Technical Newsletter

July 2025 Service Operation Team

Information on changes to IR WINDOW (XNP-Cxx03RW series)

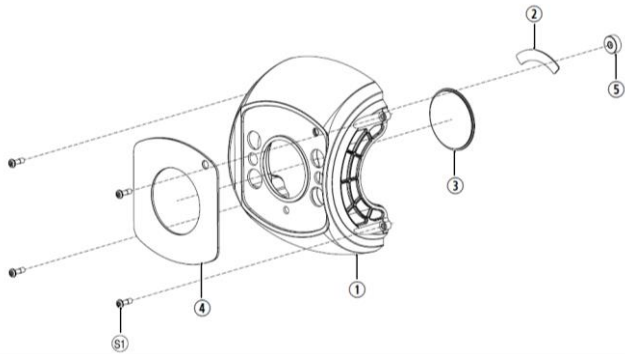
- Due to discontinuation of IR ink, the exterior cover has been restored to its original design (IR ink removed).

Part Location	Material Number	Item Name	Remarks
4	FC37-001103A	WINDOW-IR_XNP-XX03RW	Before
	FC37-001073B	WINDOW-IR_XNP-XX00RW;BLACK	After

- Backward-compatible change
- The simple design change causes no difference in performance/function,
